# Panel Submission – Part B

## Planning Scheme Amendment C131latr Flood Overlays Update

Latrobe City Council and West Gippsland Catchment  
Management Authority

Circulated 8 July 2024

Figure 18: Flood Overlays applied in Moe in Amendment C9

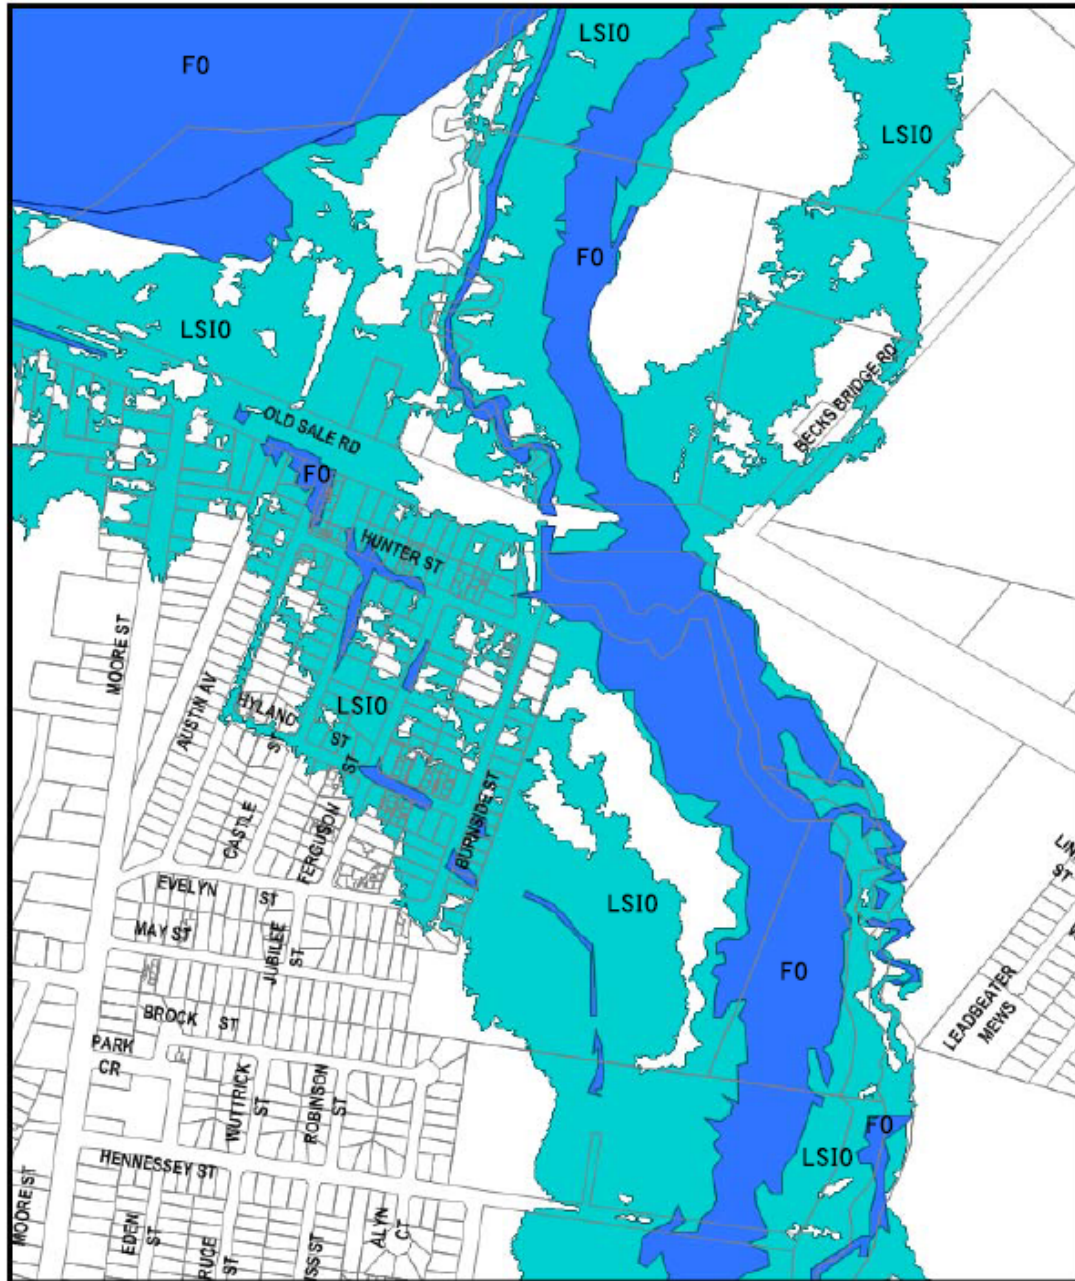
204. The flood overlays along the Narracan Creek were implemented into the Latrobe Planning Scheme in Amendment C9 on 29 March 2012, as shown in Figure 18.

205. Amendment C9 implemented the recommendations of *Narracan Creek Flood Study 2007*.
206. Amendment C9 was Exhibited to the public between 7 April 2011 to 31 May 2011, it was adopted by Council on 21 November 2011. The amendment was finalised on 29 March 2012.
207. Submitter 43 raised lack of notification as a reason why the overlay should be removed. It does appear that land ownership for 27 Castle Street, Moe changed on 12 April 2011. All landowners were notified on 28 March 2011. As such, it appears that the previous landowner was notified and did not pass on the information.
208. **Planning Comment**
209. As there is no supporting study and no overlays are proposed to change along the Narracan Creek, no changes are proposed.
